ADDENDUM 1

DATE: April 18, 2024

PROJECT: OUSD, Wagner Ranch Elementary School Path of Travel Work

FROM: HKIT Architects

DRAWING TITLE
SITE DETAILS
Addendum 01

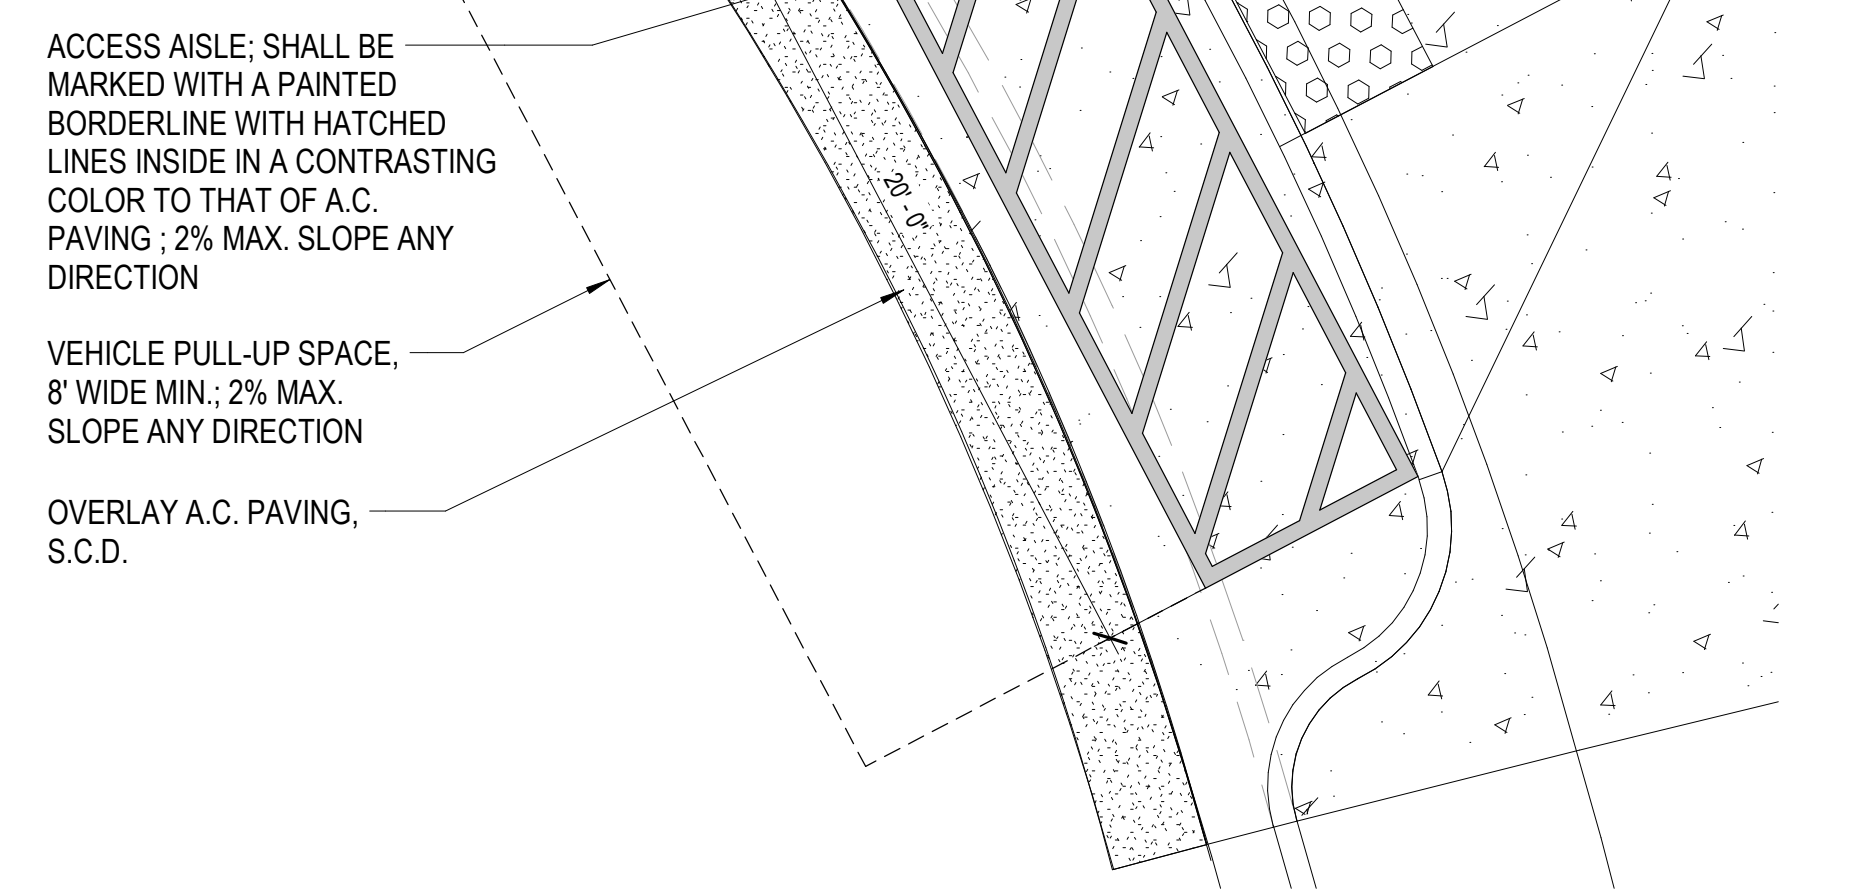
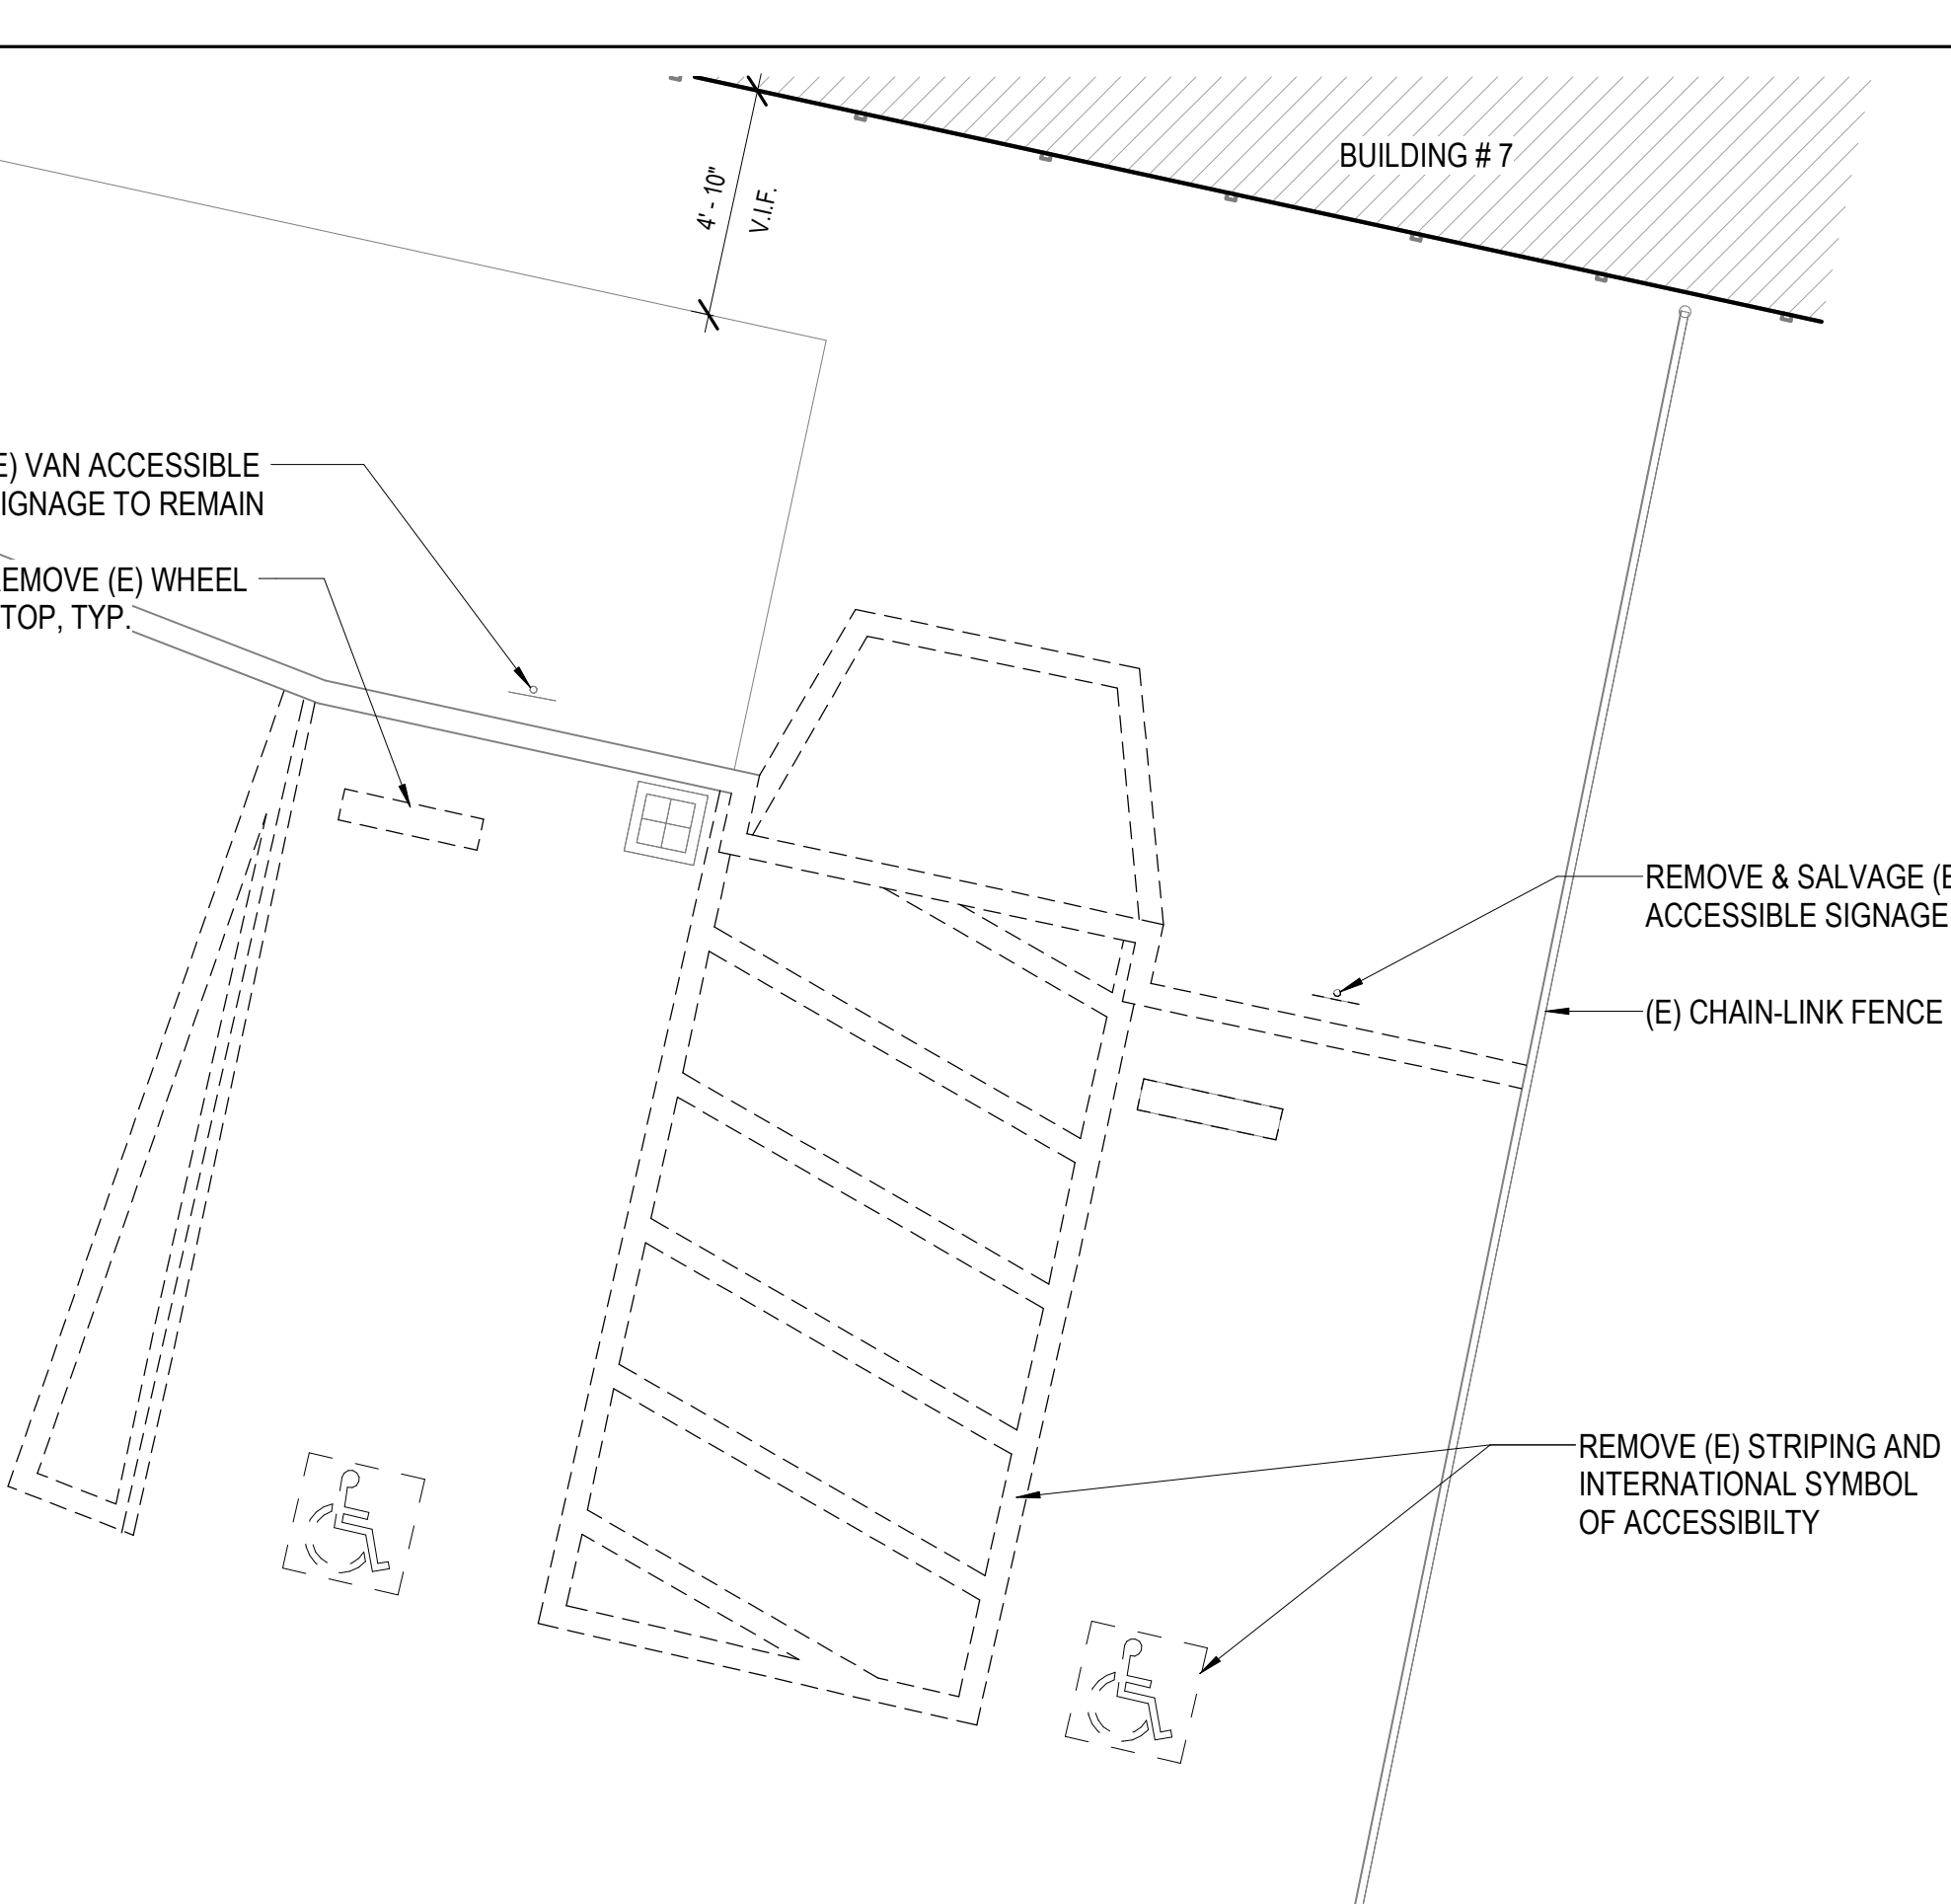
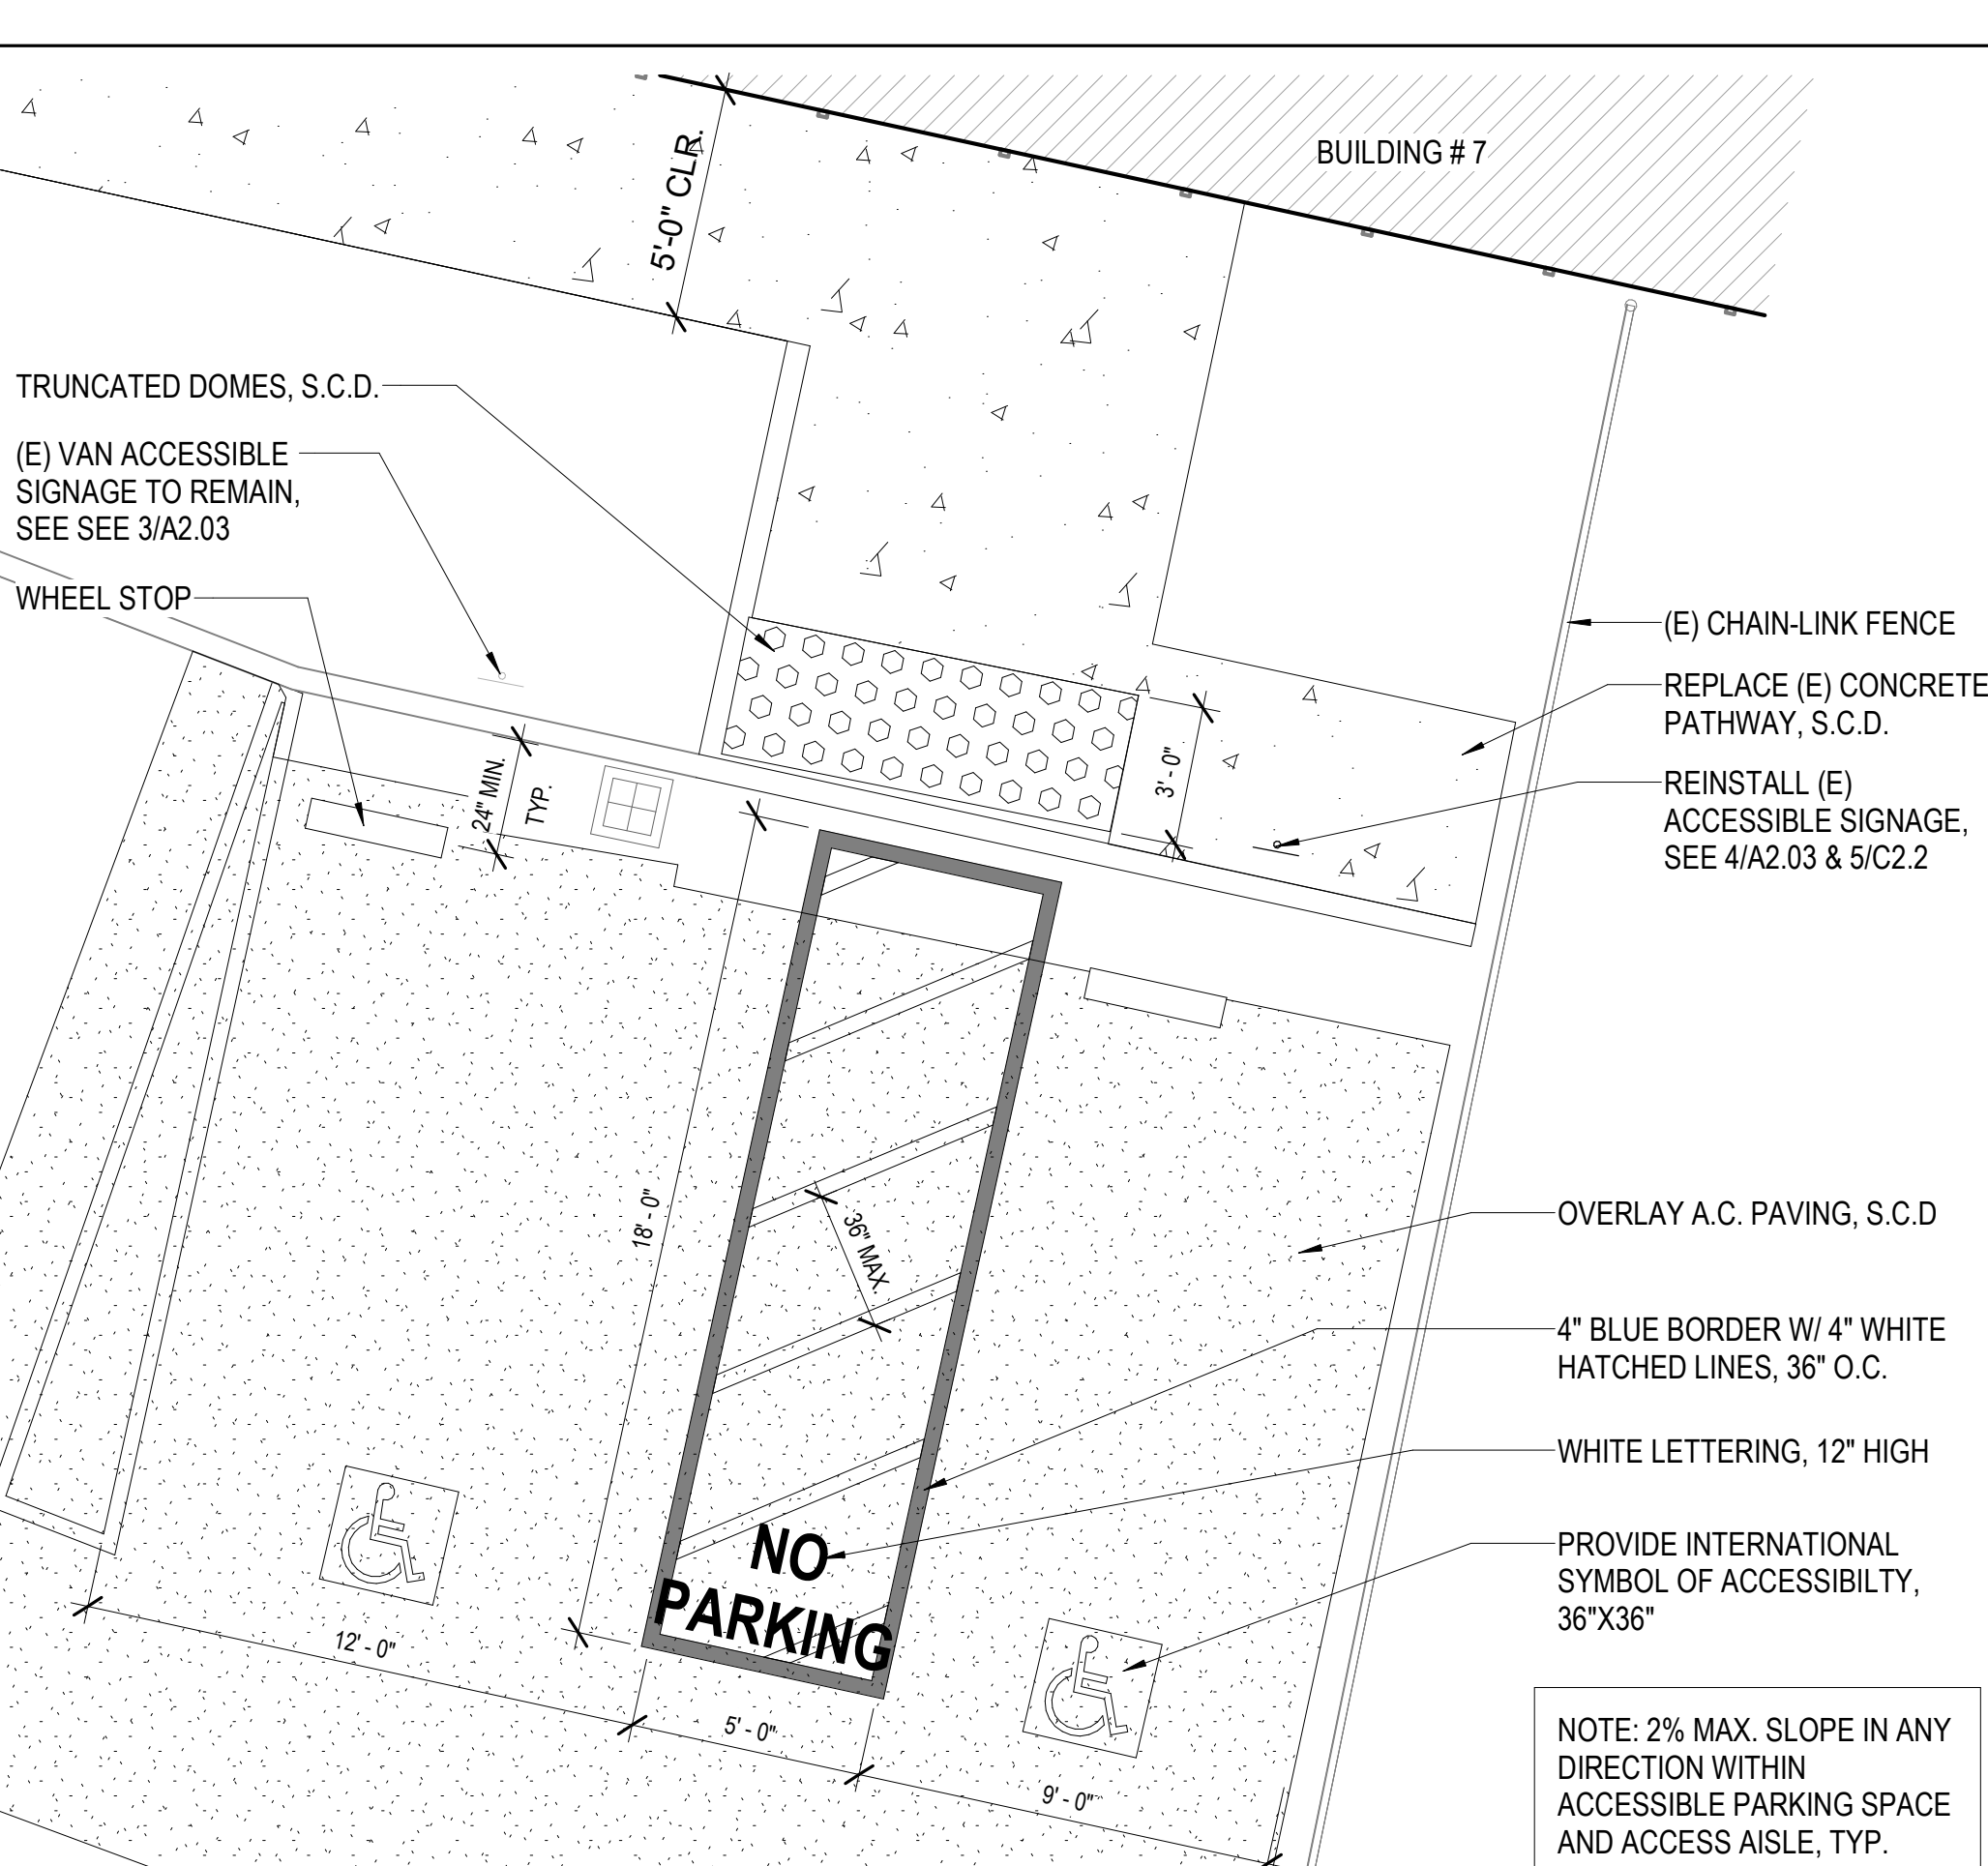
1-2 Subject: Truncated domes at curb ramps.

Description of Change: Truncated domes should be cast-in-place.
